Sabre Sailing Association of Australia

Proposed Rule Changes

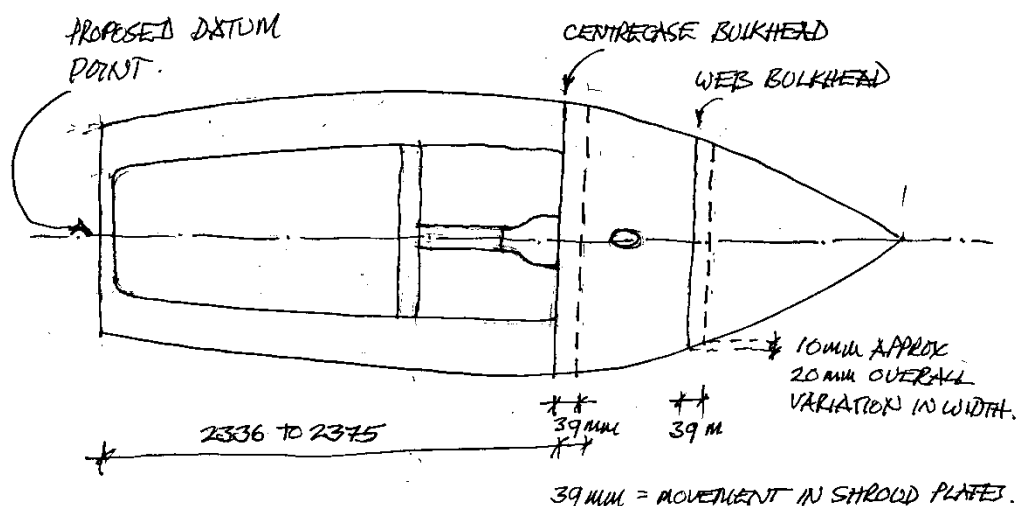
Good boat measurement practice bases all measurement on a fixed datum point. This is recognized in the ISAF guidelines.

Sabre hull measurement is largely based on a fixed datum point at the transom but diverges from this around the centrecase bulkhead measurement. Mast step position, Rocker and two of the three chine to chine measurements are based on a fixed distance from the transom datum point.

The third chine to chine measurement and two of the gunwale to gunwale measurements are based on the position of the centrecase bulkhead which can vary by 39mm fore and aft. The consequence of this is that the width of the boat is variable according to the location of the centrecase bulkhead. This variation adds another 20mm to the tolerances at the web bulkhead and approximately 10mm at the centrecase bulkhead.

By inference in the construction notes the position of the shroud plates is controlled by the location of the centrecase bulkhead whereas the mast position is controlled from the transom datum point.

SABRE DATUM POINT AND SECTION LOCATIONS

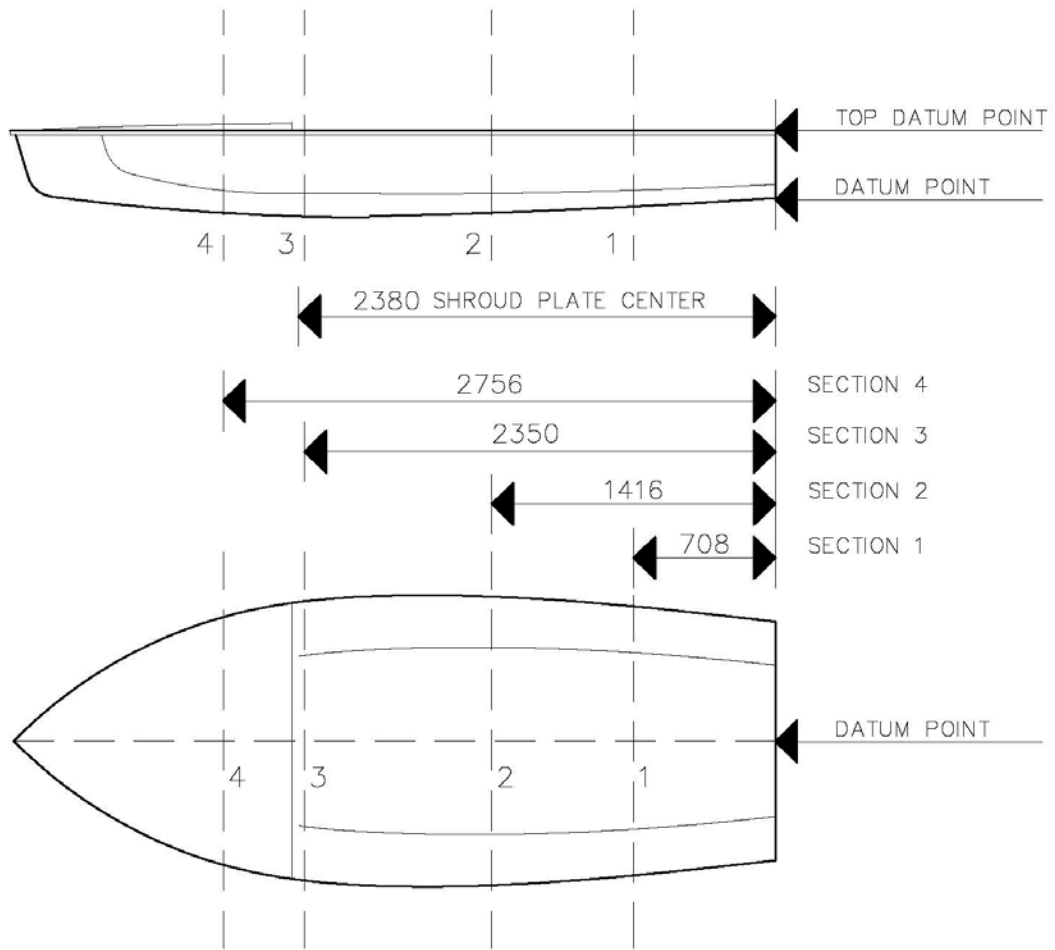
All measurements are based on one fixed Hull Datum Point.

The '**Hull Datum Point**' is – The lowest point on the aft transom where the extension of the bottom panels meet on the centreline.

For measurements at deck level this datum point is on the plane of the transom at the top of the transom at the centreline and is referred to as the '**Transom Top Datum Point**'. Note that it is the plane of the transom, not the aft side of any transom top lip.

Measurement Sections - The Measurement Sections shall be defined by the following points measured from the Hull Datum Point along the hull centreline, chines and sheer lines at deck level.

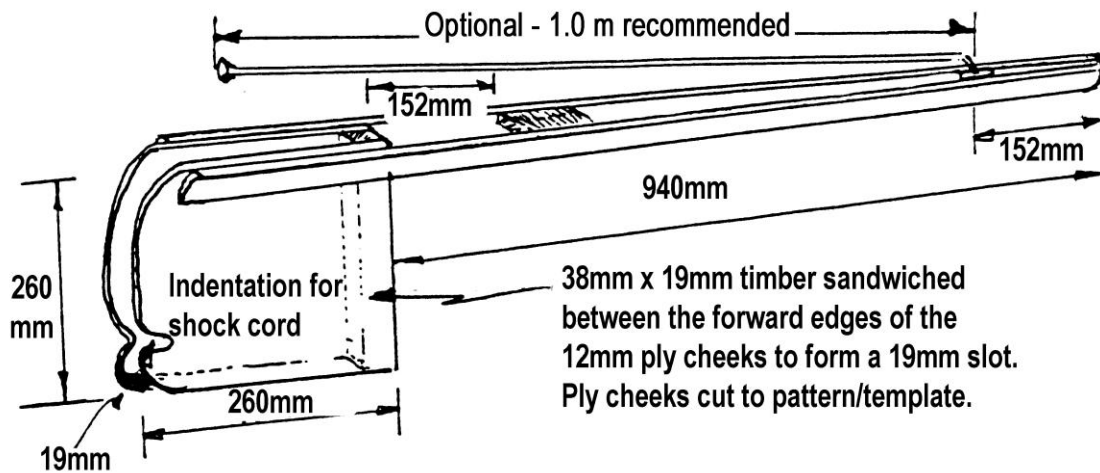
Diagrams 11 and 12 of the Construction notes refer to 12mm ply rudder cheeks and a 19mm slot. Modern rudder gudgeons have a narrower width which means that the cheeks need to be chiselled out to fit them. 9mm ply cheeks accommodate current commercial gudgeons and do not adversely affect the strength of the rudder stock. Current rules specify that rudder cheeks be made from plywood. There is no reason why the rudder box should not be a moulded FRP construction which is likely to be cost effective and possibly lead to more readily available replacements.

And that diagrams 11 and 12 shown here be changed to reflect this;

Measurement No. 70 - Rudder box may be constructed from timber or moulded FRP.

Measurement No. 71 - Rudder box cheeks to be a minimum thickness of 9mm.

Diag.#11 - Rudder Stock with Timber Tiller

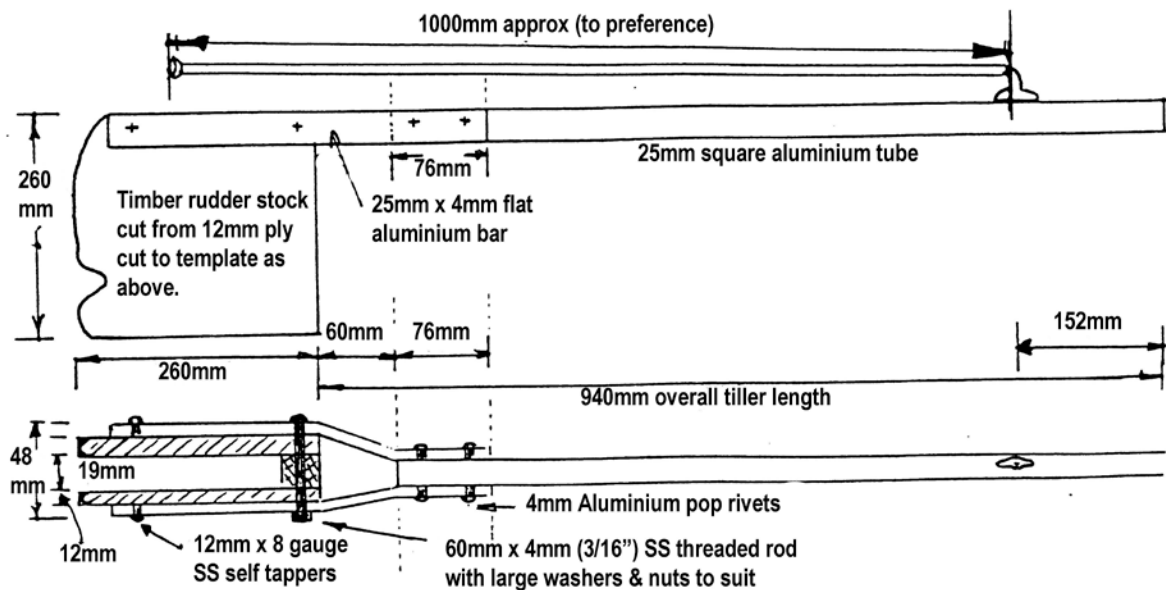
The table of measurements (57 to 72) do not contain minimum or maximum lengths for the tiller (timber or aluminium) but Diagrams 11 and 12 on page 26 of the Construction and Fitting Out Notes specify an exact tiller length of 940mm. The length of the tiller, like the tiller extension should be a recommendation only. Physical attributes of the sailor may influence tiller and tiller extension lengths.

That Diag.#11 and Diag.#12 shown below;

Change the tiller length specification from 940mm to “940mm – recommended”

Diag. #22 – Halyard Cleat Position as shown below;

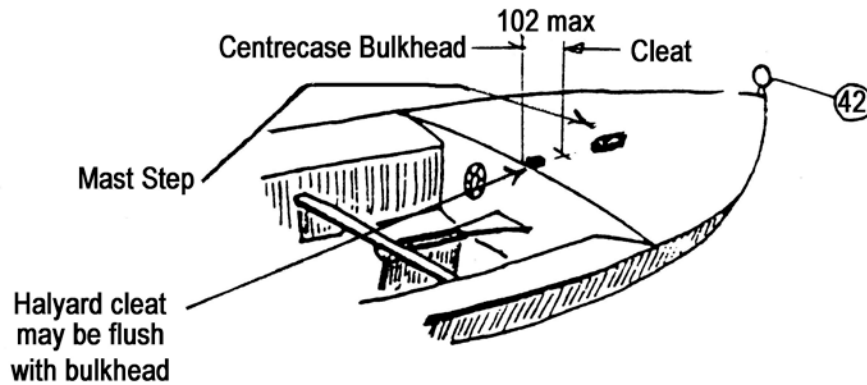
Main halyard cleated aft of 102mm forward of centrecase bulkhead		102
87		Downhaul cleated aft of 102mm forward of centrecase bulkhead		102

Be deleted and that;

Mainsheet (Rule #5.2(a), Meas #75, 82, 83, 88, Diag. #20)

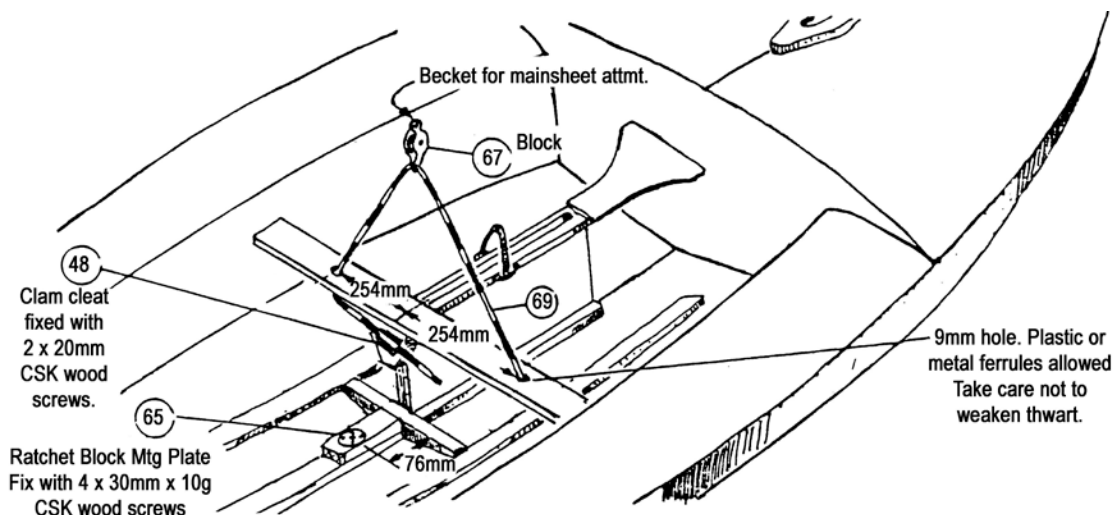
Remove references to fitting 'Item numbers'

Delete the sentence "Fit ratchet block and mounting plate to the keel cover block as shown in diagram (**Item 66**)."

Delete Diag. #20

Change the 3rd sentence to read "Fix a knot in one end of the hawse; pass through the first hole in the thwart; through the ferruled end of the mainsheet block (**Item 67**); through the second hole in the thwart, thence optionally to clam cleat fixed to the thwart or tied off to a saddle on the keel.

37. Method for attaching shrouds to mast tangs and halyard material – Diag #25A (proposal 54)

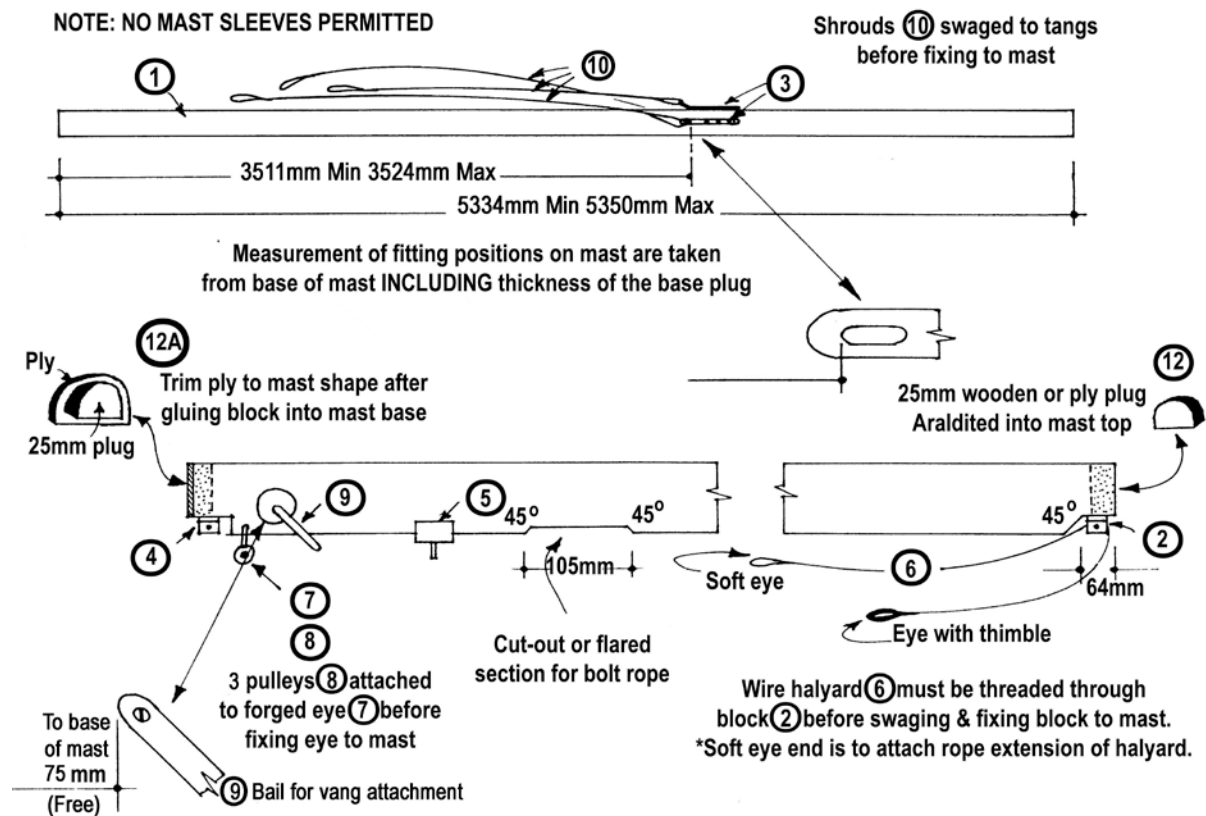
The method specified for attaching shrouds to mast tangs in Diag #25A is by permanent swage but common practice is to use cleavis pins or small shackles. The diagram refers to a ‘wire halyard’ but rope is the most common material these days. The vang attachment point drawing is obsolete.

38. Mast vang attachment point incorrectly specified in Diag #25B (proposal 55)

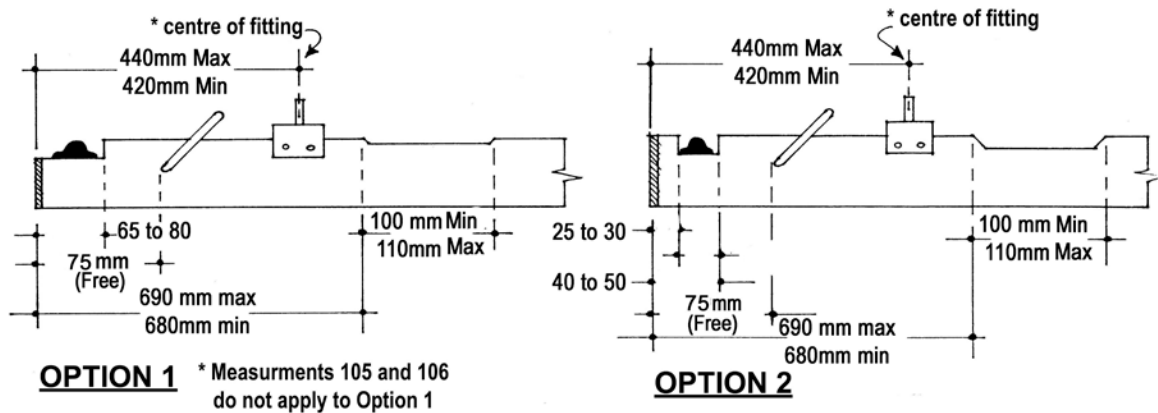
There is no longer a specification for the position on the mast where the vang is attached (rule 6.1 h. was deleted Nov 2006) but Diag #25B still shows measurement points. The diagram should indicate that the vang attachment measurements shown are a guide only.
